Draft Grid Code Modification Report		At what stage is this document in the process?												
<h1 style="color: #00a651;">GC0114:</h1> <h2 style="color: #00a651;">Mod Title: ‘System Operation Guidelines Prequalification Processes’</h2>

1 About this document

GC0114 aims to clarify that the EU System Operation Guideline (SOGL) requires NGESO to develop prequalification processes for Frequency Containment (FCR), Restoration (FRR) and Replacement Reserves (RR). In line with stakeholder feedback NGESO proposes to develop these new processes under the established governance of the Grid Code.

Figure 9 – Grid Code Primary, Secondary & High test requirements (copy Figure ECC.A.3.3 & ECC.A.3.4)

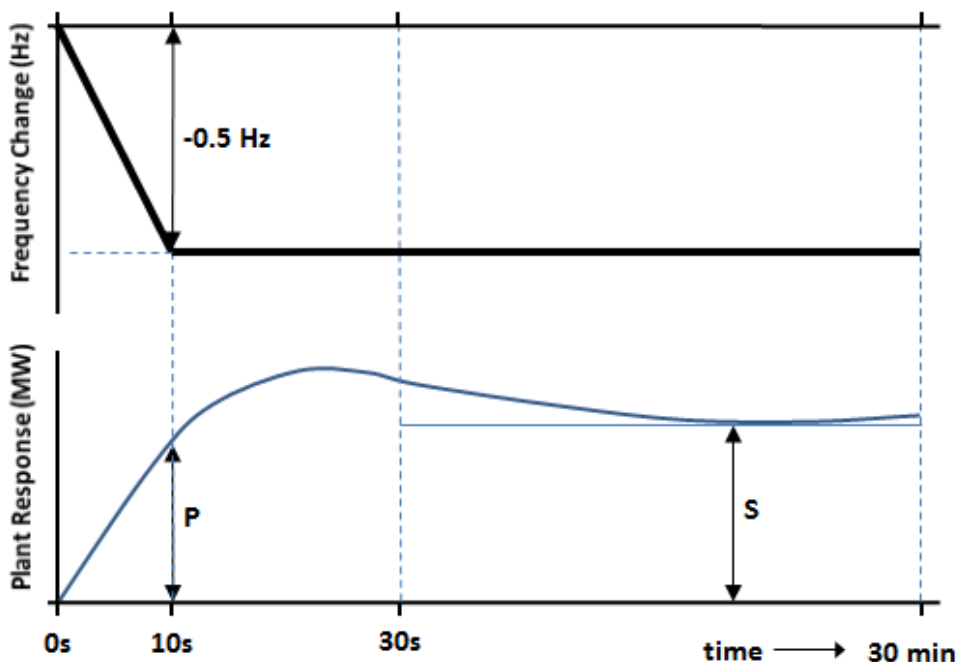
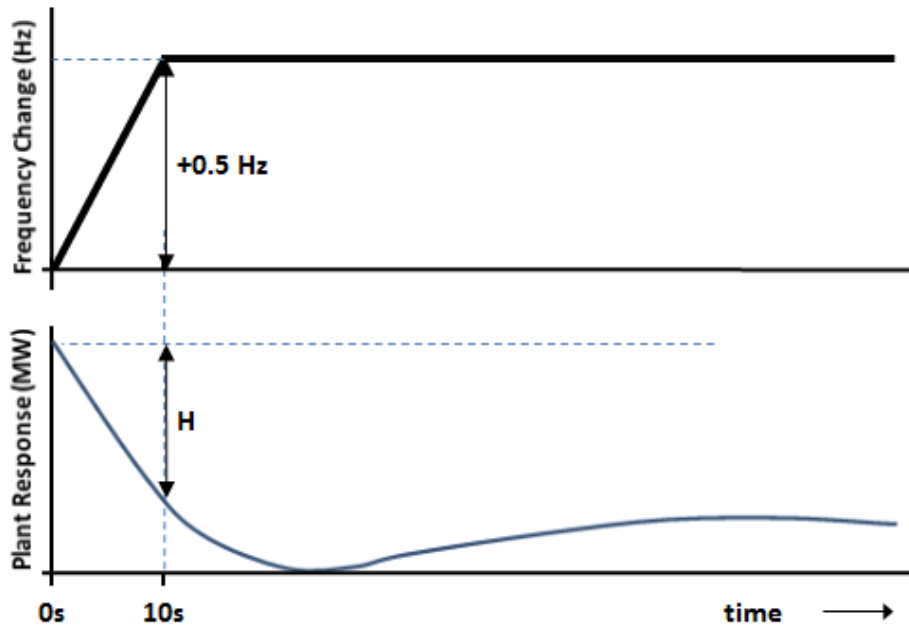
Given that all tender returns require primary, secondary and high response values it is surprising that only the MSA tests require these tests, with both the guidance documents for FFR and EFR using step tests and ramps of longer durations.

Figure 10 – Comparison of responses to a -0.5Hz step and ramp test

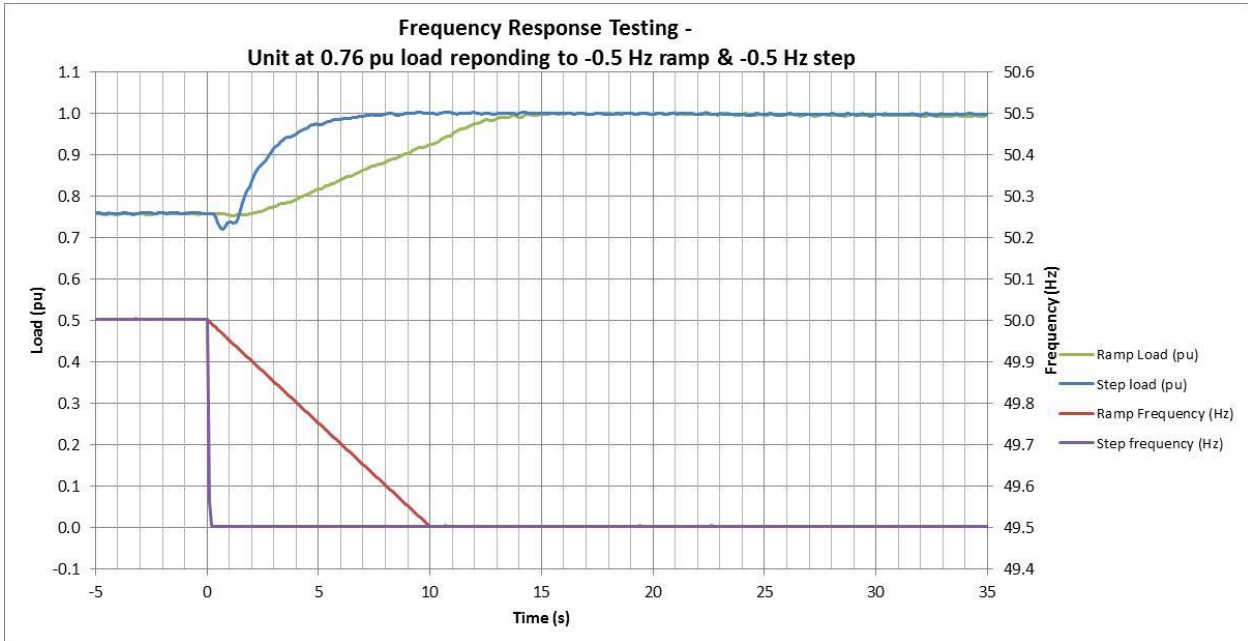
In order to demonstrate of the different responses of the following figure 10 shows the same generator on the same day being tested with a 0.5Hz frequency decrease over a 10 second ramp test 13 and a 0.5Hz step frequency decrease compliance test H. Similarly in figure 11 the same generator on the same day being tested with a 0.5Hz frequency increase over a 10 second ramp test 14 and a 0.5Hz step frequency increase compliance test I.

Reviewing the primary response in figure 10 based on a 10s ramp the response is 0.186 pu, whilst if the result is based on a step test the response is 0.241pu, hence a ramp test only gives 70% the response of a step response. Similarly the high response in figure 11 based on a 10s ramp the response is 0.191pu, whilst if the result is based on a step test the

Figure ECP.A.5.6.11.1- Test profile for an over frequency duration test

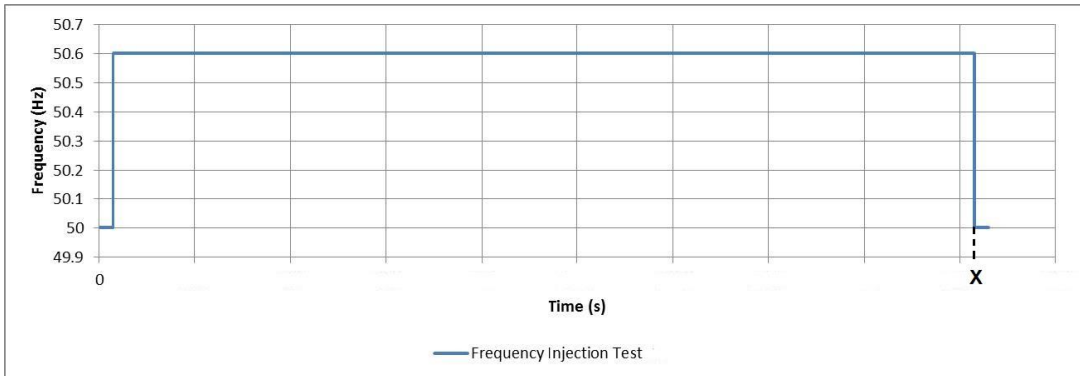
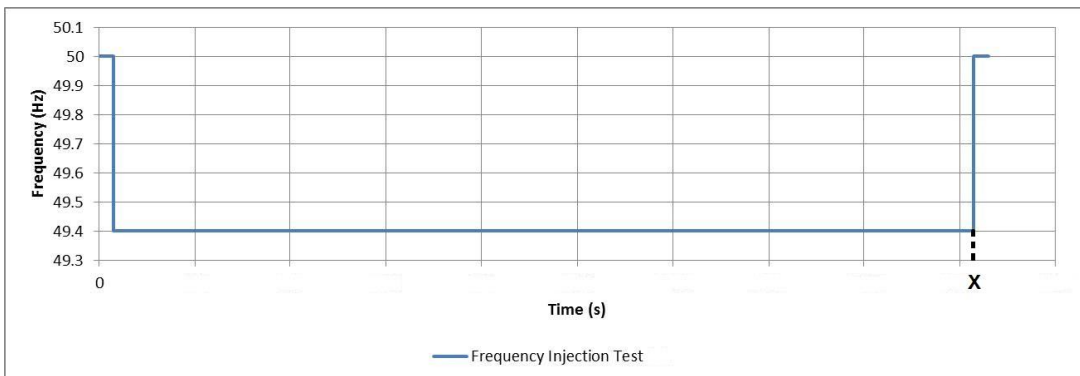
This test shall only be required if the User is wishing to offer The Company a frequency service which The Company has specified that a minimum delivery duration is required. The test shall confirm the service can be delivered for the specified contract period the frequency shall be ramped either up to 50.6Hz or down to 49.4Hz as appropriate as per ECP.A.5.6.11.1 and ECP.A.5.6.11.2 and held there for the length of the specified contract period (X), before being ramped back to 50Hz.

Figure OC5.A.2.8.11.1- Test profile for an over frequency duration test

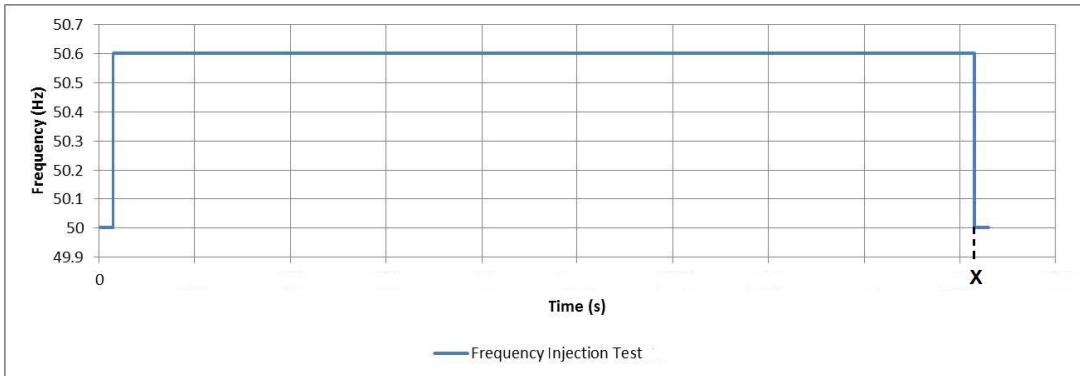
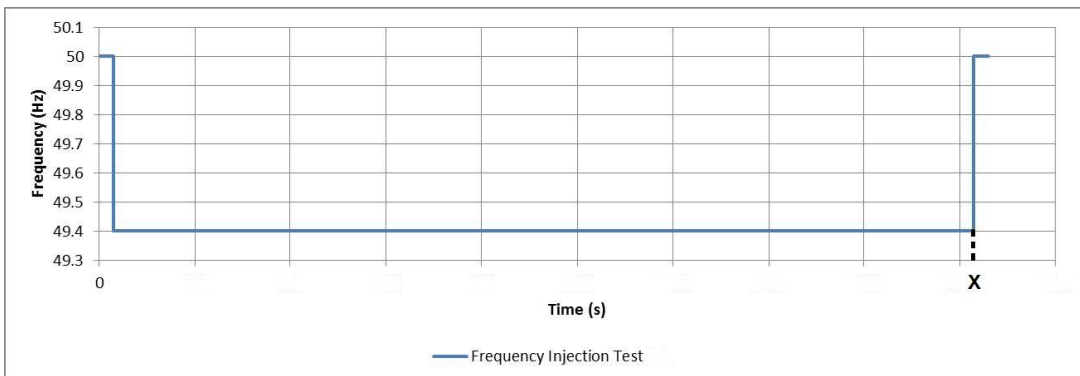
This test shall only be required if the User is wishing to offer The Company a frequency service which The Company has specified that a minimum delivery duration is required. The test shall confirm the service can be delivered for the specified contract period the frequency shall be ramped either up to 50.6Hz or down to 49.4Hz as appropriate as per OC5.A.2.8.11.1 and OC5.A.2.8.11.2 and held there for the length of the specified contract period (X), before being ramped back to 50Hz.
